MOONEY SPECIAL LETTER 15-17
Date: 9-21-2015

- SUBJECT:** To ADVISE MOONEY OWNERS/OPERATORS of the **LYCOMING Service Bulletin No. 621A (Supersedes Service Bulletins No. SB-621) Issued September 2, 2015 - Diaphragm-Type Fuel Pump Replacement (see attached).**

DATE: September 2, 2015 Service Bulletin No. 621A
(Supersedes all versions of Service Bulletin No. 621)
Engineering Aspects are
FAA Approved

SUBJECT: Diaphragm-Type Fuel Pump Replacement

Figure 1
Manufacturer's Code Location on
Fuel Pump P/Ns 62B26931 and LW-16335

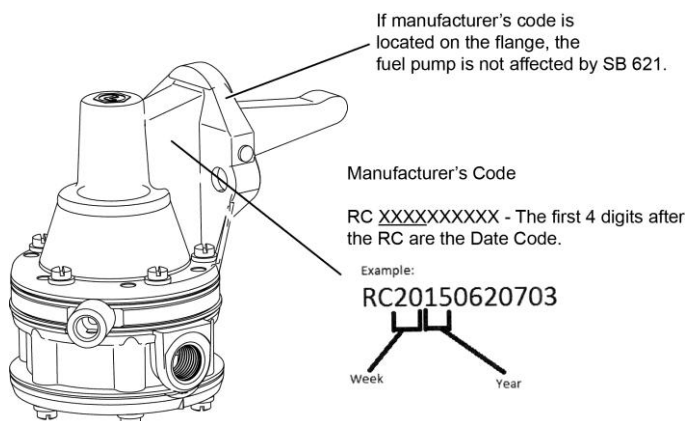
NOTICE: Each fuel pump has a 13-digit alphanumeric manufacturer’s code, which begins with two letters as shown in the example in Figure 1. The alphanumeric characters in the manufacturer’s code and its location on the fuel pump will help identify the fuel pumps affected by this Service Bulletin. The first two characters in the example manufacturer’s code RC20150620703 in Figure 1 are **RC**. The next two numbers **20** identify the manufacturing week of the year as **20** and **15** is the year. The manufacturer’s code is on the fuel pump flange or on the web as shown in Figure 1. If the manufacturer’s code is on the flange as in the example in Figure 2, the fuel pump is not affected by this Service Bulletin.

1. If the fuel pump is Lycoming part number 62B26931 or LW-16335.
2. If the manufacturer's code is not on the flange but is on the web or other parts of the fuel pump.
3. If the fuel pump has **RC** (Figure 1) as the first two letters of the manufacturer's code.
4. If the manufacturer's code identifies the fuel pump as manufactured before, up to, and including the 25th week of 2015.

If any fuel pump meets **all** the criteria above, remove the fuel pump from the engine or from the spares inventory and:

- A. Review your records to identify shipping dates of the serial numbers of any of the affected fuel pumps.
- B. Return all affected fuel pumps to Lycoming Engines with a copy of this Service Bulletin and file a warranty claim per the warranty procedure herein.
- C. Record removal of the fuel pump installed on the engine in the engine logbook.
